CERTIFICATE OF THE SECRETARY OF ENERGY AND ENVIRONMENTAL AFFAIRS  
ON THE  
FINAL ENVIRONMENTAL IMPACT REPORT

PROJECT NAME	: North Carver Development and Urban Renewal Plan
PROJECT MUNICIPALITY	: Carver
PROJECT WATERSHED	: Taunton River
EEA NUMBER	: 15639
PROJECT PROPONENT	: Route 44 Redevelopment, LLC
DATE NOTICED IN MONITOR	: March 6, 2019

## Pathway to Emissions Elimination

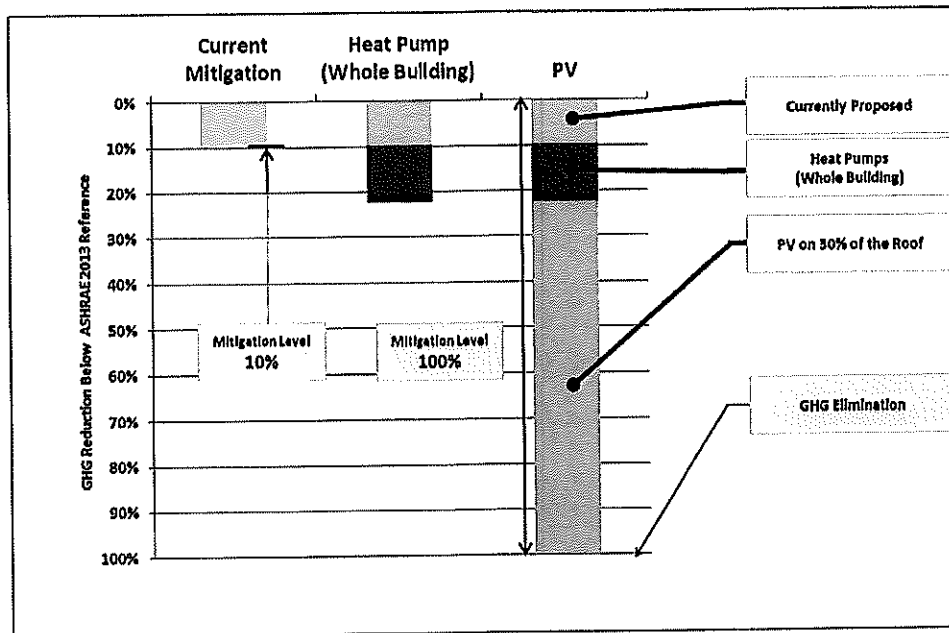
The currently-planned GHG reduction is reported to be 10%. Emissions can be eliminated, as illustrated below:

- Expanding heat pump (or VRF) heating from just the office portions of the buildings to all the buildings' area would more than double GHG mitigation, improving reduction to 22%.
- Addition of solar PV on about 30% of the total roof area would eliminate the balance of all emissions.

1. Examine expanding heat pump space heating to the entire building, including consideration of value of Alternative Energy Credits (AECs) and benefit of on-site production from PV. Also, examine switch to electric-based water heating which would allow elimination of gas service from the project and cost savings.
2. Incorporate solar PV on at least 30% of the roofs. Confirm commitment to set aside 80% of roof to be PV-ready.
